Hills of Gold Wind Farm

Submissions Report

20 December 2021

Project No.: 0550690

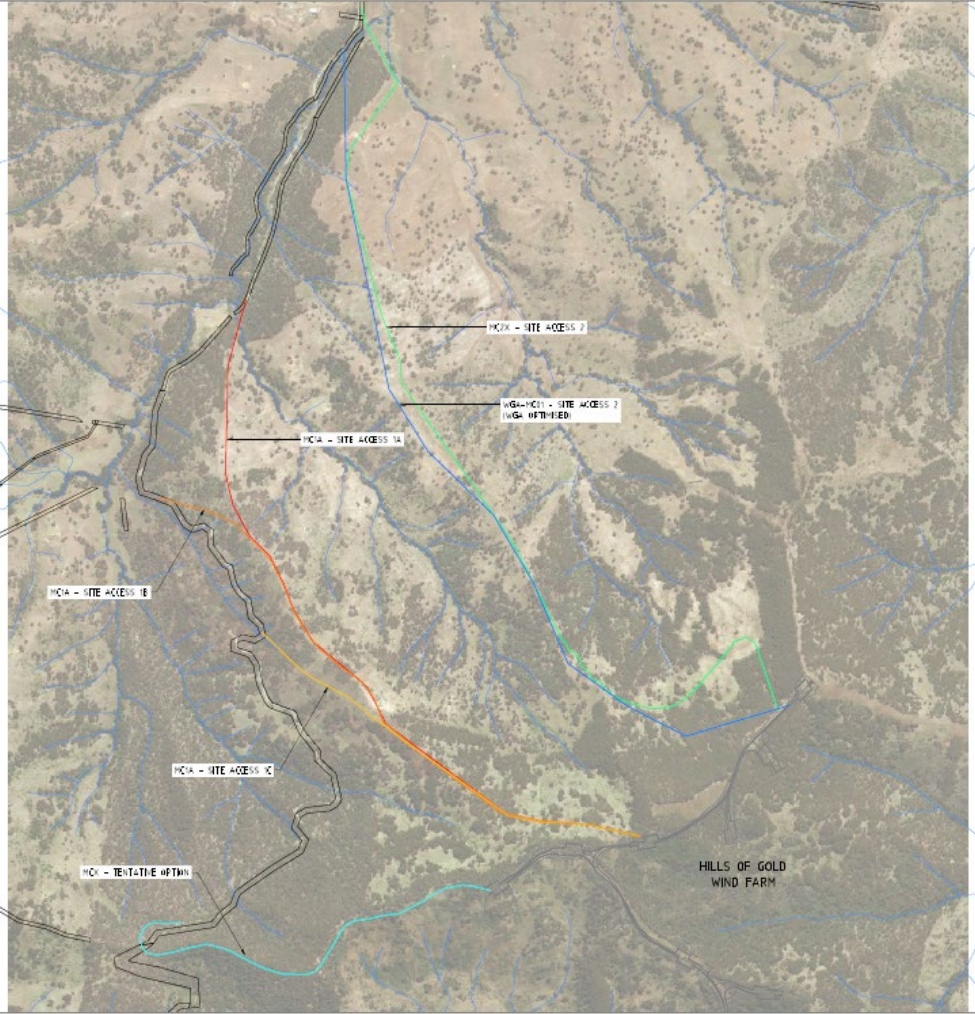
DPIE_10	Transport Route	Provide a detailed analysis of alternative route options and justification for the preferred option.	<div>Six site access options were assessed during the preliminary assessment phase of the Project. These options are detailed below. Option 6 along Nundle Creek Road was removed early in the process due to lower quality existing public road, creek crossings, tight bends in the road, and significant new road modifications required. The five remaining access options were assessed by Siemens-Gamesa's (experienced turbine manufacturer and installer) civil engineering team with a focus on minimising public road modifications required, optimising road geometry and minimising grade, and minimising total earthworks required.</div> <div><div><div>Access Options</div><div><ul style="list-style-type: none">32-36km from New England Highway to Nundle3 existing local road options to site entranceOptions to site ridge line require upgrades to existing tracks</div></div><div>Siemens-Gamesa carried out site visits and design analysis to determine the viability and constructability of each route option to enable turbine component delivery. Their analysis showed that Option 5 (Barry Road) presented as the most practical route based on the following conclusions:</div><div><div>■ Majority of access defined over existing public roads, with the shortest length of new access road construction required.</div></div></div>

Reference No.	Theme	Submission	Response
			<div><div><div></div><div>Lowest existing natural ground slopes of all access options.</div></div><div><div></div><div>Lowest designed max slope of all access options.</div></div><div><div></div><div>Lowest total earthworks required of all viable options.</div></div></div> <div>Additional assessment conducted also found that:</div> <div><div><div></div><div>Head of Peel Road (Options 3 and 4) features a bridge and nine causeway creek crossings within a working cattle station that includes number of cattle grids meaning a significant amount of upgrade works would be required. . Head of the Peal Road also includes possible impacts to three identified Aboriginal sites, including one Potential Archaeological Deposit.</div></div><div><div></div><div>Option 5 includes the use of Barry Road, which is also frequently used by forestry trucks travelling to and from Werris Creek.</div></div><div><div></div><div>Option 5 requires the least encroachment onto private landowners properties along the route of all the options assessed.</div></div><div><div></div><div>Options 1-4 would require RAVs to either double pass through Nundle along Oakenville Street, Old Hanging Rock Road, Happy Valley Road, River Road, Jenkins Street and the Crawney Road loop, or pass through residential areas of Nundle including Herron Street, Innes Street, Gills Street, Jenkins Street, and Crawney Road.</div></div></div> <div>Since the lodgement of the EIS, the Proponent engaged Wallbridge Gilbert Aztec (WGA) to further consider alternate route options to site from a civil engineering perspective, and to progress an optimised design of the selected route. WGA have provided civil design services for over 15 wind farms in Australia. WGA compared a number of route options including the existing Devil's Elbow bypass route as well as a number of alternate route options off Crawney Road up to the western side of the Project, shown below. WGA's assessment found that these other options assessed would require approximately between 3 to 7 times the total length of required new road construction compared with the Devil's Elbow bypass, and a minimum of 10 times the total amount of earthworks required to complete the road construction. This would result in significantly more disturbance footprint for these route options. Based on this assessment WGA selected the Devil's Elbow bypass as the most viable transport route for the Project and completed an optimised design for this route.</div>

Reference No.	Theme	Submission	Response
			<div></div> <p>ROAD LAYOUT OPTIONS – SITE ACCESS</p> <p>Site visits to the proposed Devil's Elbow bypass area were also undertaken as part of the optimised design process with a number of civil contractors experienced in the construction of wind farms, as well as a site visit with Soil Conservation Services to gain feedback on optimal road alignment, construction techniques, and typical environmental impact mitigations during construction. A summary of the impacts that were considered and avoided in the optimised road design include:</p> <ul style="list-style-type: none">■ Addendum to the SOHI was completed by ERM to identify the risk of indirect impacts to the Black Snake Gold Mine heritage setting.■ Road was designed to avoid the known mine entrance in the area to the north of the gully.■ Road was designed to stay on the natural ridgeline and avoid crossing the gully.■ Road was designed to ensure the section of road traversing the location with possible presence of tunnels be in fill rather than cut, as suggested by the geotechnical engineering assessment.■ Safe tie ins with public road (Barry Rd) at top and bottom of the bypass road, as well as tie ins with the existing walking tracks in the area were considered.■ A balance between disturbance footprint reduction and minimising designed grades was considered. The final outcome of assessed disturbance footprint for the transport route in the Revised Project compared with the Original Project is a reduction from 17 Ha to 2.4 Ha (17 Ha was the total footprint considering several options combined for worst case design in the EIS, and further design was always intended to reduce impact. Avoiding Head of the Peel specifically saved 4 ha of native vegetation, the balance of avoided native vegetation was due to avoided alternate design options at Devil's Elbow and design optimisation of the preferred and optimised option).■ Pavement surface of the bypass road to be asphalt to ensure suitable traction for the OSOM delivery vehicles.
